AGENDA
HISTORIC PRESERVATION / DESIGN REVIEW COMMISSION
(SPECIAL MEETING)

1. Request from Luke Hilgers for design review to reconstruct a weakened portion of the façade at **1141-57 Main Street (Parcel IDs 2408-32-2026-01)**.
2. Adjourn.

Reconstruct Facade - Design Review
1141-57 Main Street
September 16, 2015

OPTION B: EAST ELEVATION

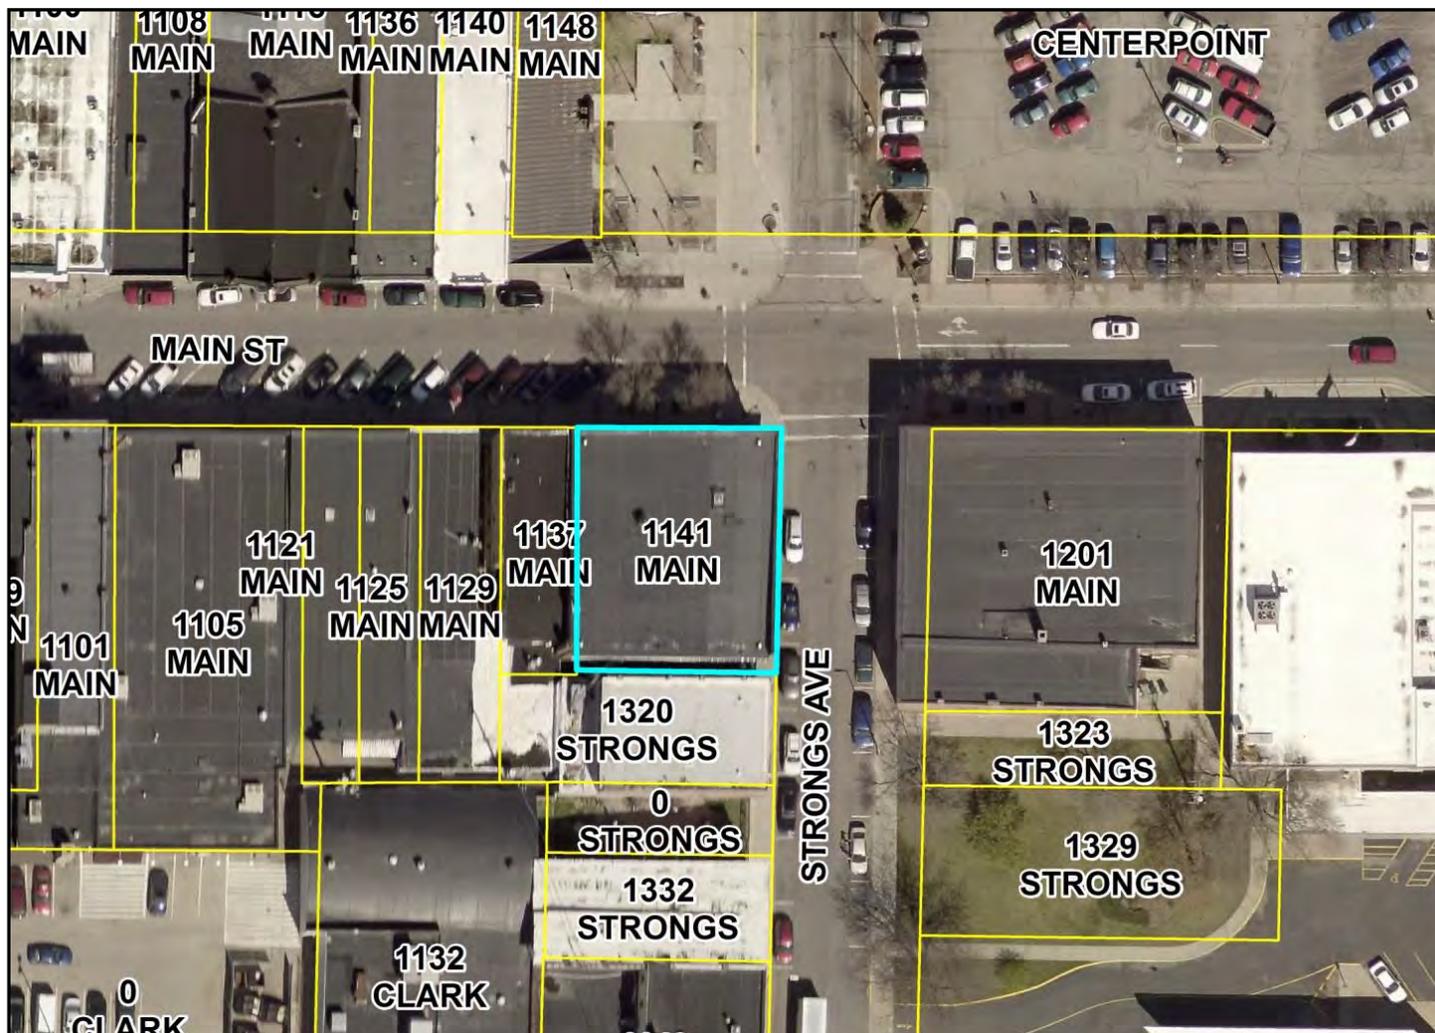
Analysis: The request involves fixing the exterior of the east façade of the building, spanning approximately 35 feet. Furthermore the project involves the following:

- a. Creation of a temporary wall,
- b. Removal of approximately 465 square feet of brick below the lintel and 200 square feet of glazing (three window units),
- c. Addition of structural steel framing,
- d. Faming of windows,
- e. Installation of approximately 315 square feet of exterior glazing (transoms included) and,
- f. Installation of approximately 72 square feet of stone for columns.

It is important to note that the existing awning will be permanently removed with the proposal. Furthermore, additional glazing in the form of transom windows is proposed.

Findings: The proposal will fix a significant issue on a contributing building within the historic district. Note that the building has been changed significantly since the original character, as the photo shows, with the extension of storefront windows and removal of windows below the lintel. The new proposal will assist in restoring transoms windows, while maintaining the existing storefront windows. Furthermore, it will incorporate designs found on the north side of the building. The applicant is proposing stone for the columns as adding another brick will create three different variations on the east side of the building. Staff would recommend brick exist above the proposed storefront and transom windows rather than the proposed decorative sheathing. In addition staff would recommend that window panes, and window framing match closely in texture, size, color, and material with the previous and/or existing.

Analysis: Brick closely matching the original currently exist between windows as well as, above and below the storefront windows along the east façade. A sheathing of synthetic or wooden material exists on the north façade and partially on the east façade which separates the first floor and second floor windows, as well as on the base of the building. Note the awning has been removed to perform further analysis of the façade.

Findings: As the existing sheathing is not historic and does not exist currently within the project area, staff would recommend that the brick remain above the storefront and transom windows. The awning is not proposed to be replaced which somewhat mimics the original façade depicted in the photo above where only a small awning exists. Note that awnings do not exist on the north façade.
